Project	IEEE 802.16 Broadband Wireless Access Working Group < http://ieee802.org/16 >		
Title	Proposal for IEEE 802.16m System Architecture and Protocol Structure		
Date Submitted	2008-01-16		
Source(s)	Jeff Bonta, Mike Baker, George Calcev, Benedito Fonseca, Nitin Mangalvedhe, Nathan Smith, Mark Cudak, Steve Emeott Motorola	E-mail:	jeff.bonta@motorola.com mark.cudak@motorola.com steve.emeott@motorola.com * http://standards.ieee.org/faqs/affiliationFAQ.html >
Re:	IEEE 802.16m-07/047. Contribution pertains to: Proposed IEEE 802.16m Reference Model and potential System Architectures Proposed 802.16m Protocol Architecture and main functionalities per protocol layer		
Abstract	This contribution proposes that the group adopt simple and concise reference architecture identifying all the air interface links the group will be developing—a BS to MS, RS to MS and RS to MS links—along with only the essential outline of the remaining network architecture. Moreover, this contribution proposed the group adopt a protocol architecture that describes only the fundamental components of IEEE 802.16m protocol stacks. Finally, this contribution further suggests that the IEEE 802.16m include Peer-to-Pee

Figure 1 - Overall Network Architecture

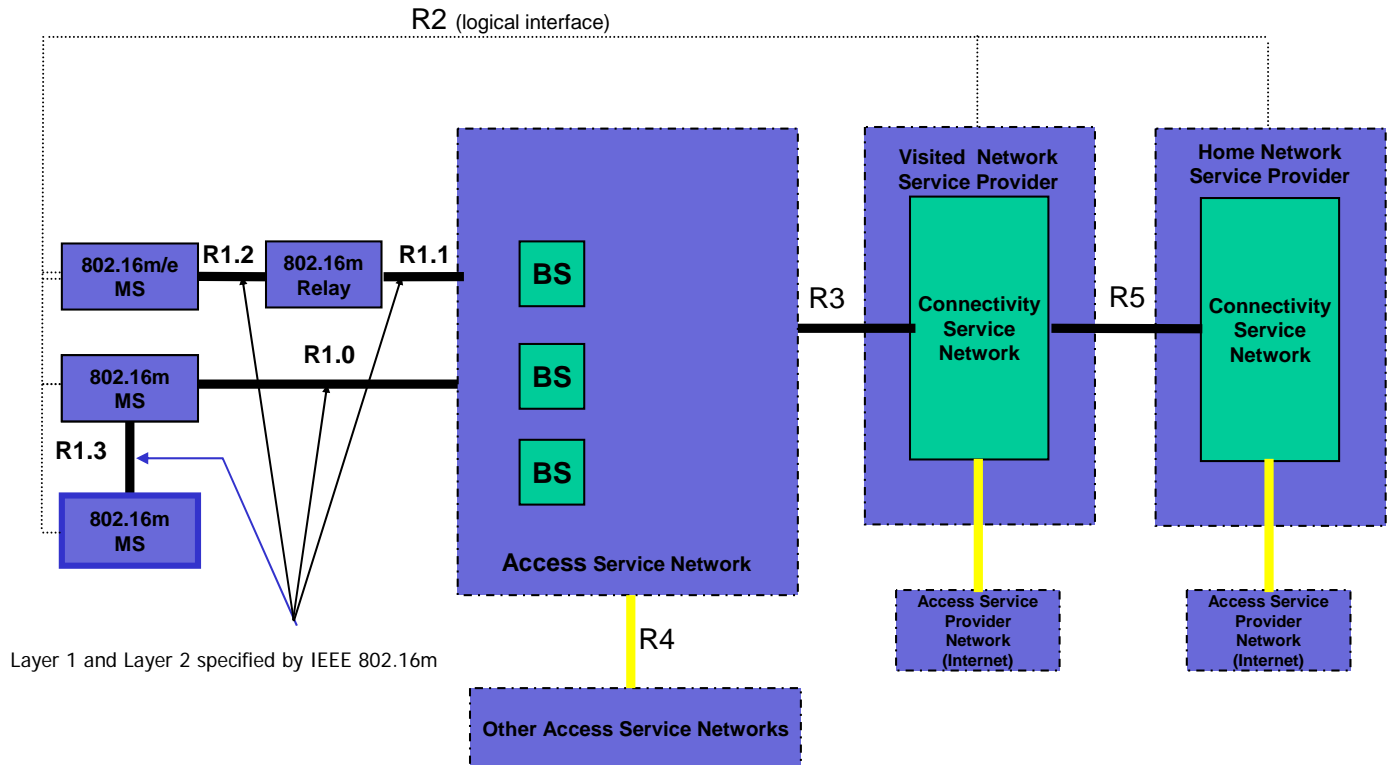
Figure 1 depicts the overall network architecture as captured in contribution IEEE 802.16m-07/297. The figured has been modified to include the following

- Names suitable for reference for the various air-interface links to be captured by the IEEE 802.16m amendment: BS to MS, BS to RS and RS to MS. (i.e. R1.0, R1.1, R1.2)
- The addition of a MS to MS ad-hoc link consistent with P2P modes included in the IMT-Advanced Network Topology (i.e. R1.3).

In the section titled “Overall Network Architecture (informative)”, include Figure 1 from this contribution inclusive of the R1.3 interface and optionally include the supporting text from section 1 of this contribution

Figure 2 - IEEE 802.16m Air-Interface Protocol Structure

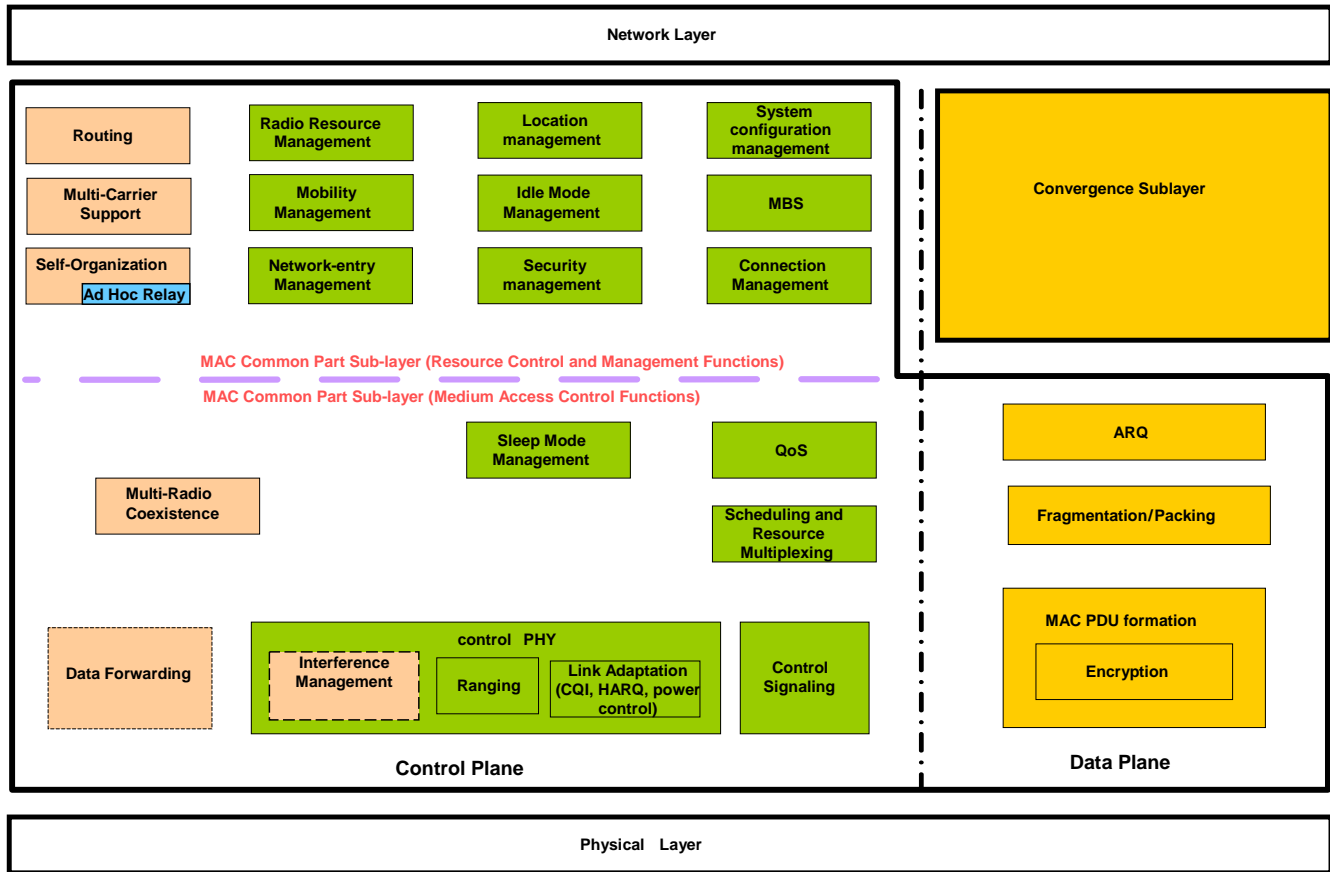
This figure is a modified version of the IEEE 802.16m Protocol Structure found in contribution C802_16m-07/297. The additions to this figure have been shown in blue and are further discussed with in the sections below. For convenience, the MAC CPS functions are logically classified into two groups based on their characteristics. The upper group is named resource control and management functions, and the lower group is named medium access control functions. The control plane functions and data plane functions are also separately classified.

IEEE 802.16m builds on the MAC architecture of current IEEE 802.16e. In our proposed MAC architecture for IEEE 802.16m, we include additional functional blocks for newly proposed features, identified as:

- Routing
- Multi-Carrier Support
- Self-Organization

IEEE 802.16m builds on the MAC architecture of current IEEE 802.16e. In our proposed MAC architecture for IEEE 802.16m, we include additional functional blocks for newly proposed features, identified as:

- Multi-Radio Coexistence
- Data Forwarding
- Interference Management

In the section titled “IEEE 802.16m Air-Interface Protocol Structure”, include Figure 2 from this contribution and optionally include the supporting text for the functional block definitions found in section 3 of this contribution.
